SUBDIVISION COMMITTEE  
METROPOLITAN AREA PLANNING COMMISSION

STAFF REPORT  
(Preliminary Plat)

CASE NUMBER: S/D 88-81 BSF Addition

STAFF REPORT  
(Final Plat; Preliminary Plat Approved 10/20/89)

VICINITY MAP:

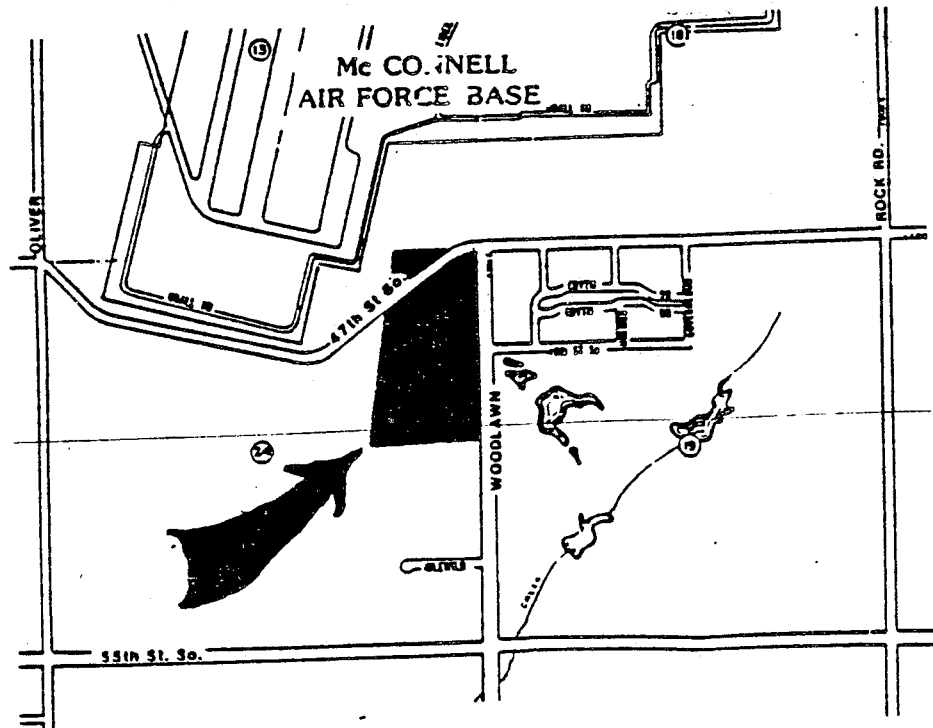
Note: The area shown on this preliminary plat as zoned "LC" is presently zoned "R-1(Lot 2, Block B). Lot 11 and part of Lot 10, which are proposed for single family development, are presently, zoned "LC". The applicant will therefore need to request the rezoning of these sites to correspond to the type of development being proposed.

- A. Since neither municipal water nor sanitary sewer is available to serve this property, the applicant shall contact the Environmental Health Division of the Health Department to find out what tests may be necessary and what standards are to be met for approval of on-site sewerage facilities and water wells. A memorandum shall be obtained specifying approval.

- B. The applicant shall guarantee any drainage improvements required by the platting of this property.
- C. The applicant shall guarantee the improvement of Woodlawn Ct. to suburban street standards.

- E. Since this plat involves the platting of a floodway, the plattor's text on the final plat shall reference the standard floodway language.
- F. On the final plat additional information shall be provided for determining the floodway boundary within the lots. Dimensions from lot corners, distances and bearings shall be provided so as to explicitly define the floodway.

- G. If required, minimum building pad elevations shall be noted on the face of the plat as well as in the plattor's text. The location and elevation of permanent on-site and off-site benchmarks shall also be indicated. Section 5-402(N).

- H. Prior to this plat being scheduled for City Council review, the zone changes indicated in the above for Lots 2, 11 and Part of 10, Block B shall be obtained.

- J. The applicant shall submit an avigational easement covering all of subject plat and a restrictive covenant assuring that adequate construction methods will be used to minimize the effects of noise pollution in the habitable structures constructed on subject property.

- K. The applicant shall submit a copy of the instrument which establishes the Cities Service Gas Line Easement on this property. The applicant's agent shall determine any setback requirements from the pipeline by researching the text of the pipeline agreement.

- L. Any relocation, lowering or encasement of the pipeline, made necessary by this development, will not be at the expense of the City.
- M. On the final plat, dimensions shall be indicated to the center line of the pipeline from the northwest corners of Lot 1, Block A and Lot 2, Block B.

- N. Prior to, or at the time of submitting the final plat, the applicant shall submit a drainage plan to County Engineering for review and approval.
- O. To receive mail delivery without delay, and to avoid unnecessary expense, the applicant is advised of the necessity to meet with the U.S. Postal Service Growth Management Coordinator (phone 316-946-4527) prior to development of the plat so that the type of delivery, and the tentative mailbox locations can be determined.

- T. The representative from the County Engineer's office should be prepared to comment on the status of the applicant's drainage plan. Specifically, is the minimum building pad correct, are the boundaries of the floodway adequate and are any drainage guarantees required with the platting of this property?

VICINITY MAP:

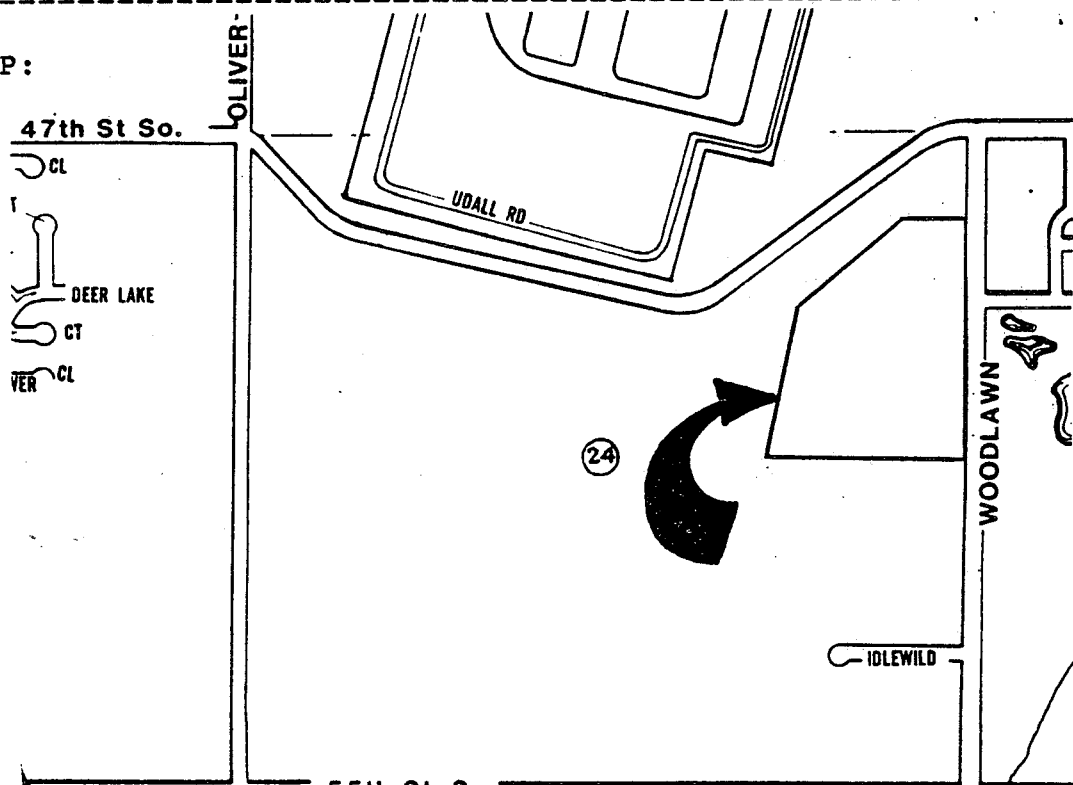
- NOTE: Lot 9 and part of Lot 8, which are proposed for single family development, are presently zoned "LC". The applicant therefore needs to request the rezoning of this site to correspond to the type of development being proposed. This plat is being finalized as a portion of an overall preliminary plat.

- A. Since neither municipal water nor sanitary sewer is available to serve this property, the applicant shall contact the Environmental Health Division of the Health Department to find out what tests may be necessary and what standards are to be met for approval of on-site sewerage facilities and water wells. A memorandum shall be obtained specifying approval.

- B. The applicant shall guarantee any drainage improvements required by the platting of this property.
  - C. The applicant shall guarantee the improvement of Woodlawn Ct. to suburban street standards.

- E. Since this plat involves the platting of a floodway, the platting's text on the final plat shall reference the film and page of the existing agreement. A copy of this agreement shall be submitted to the Planning Department.

- F. In order to maintain the integrity of the floodway along the north side of this plat, the final plat tracing shall include in the perimeter of Lot 1, the area of the floodway adjacent to the north line of this lot and indicated on the preliminary plat.

- G. Prior to this plat being scheduled for City Council review, the zone change indicated in the above note for Lot 9 and Part of 8, Block A shall be obtained.

- J. The applicant shall submit an avigational easement covering all of subject plat and a restrictive covenant assuring that adequate construction methods will be used to minimize the effects of noise pollution in the habitable structures constructed on subject property.

- L. Perimeter closure computations shall be submitted with the final plat tracing. Section 5-101(c).
- M. Recording of the plat within 30 days after approval by the City Council.

- P. The representative from the County Engineer's office should be prepared to comment on the status of the applicant's drainage plan. Specifically, is the minimum building pad correct, are the boundaries of the floodway adequate and are any drainage guarantees required with the platting of this property?
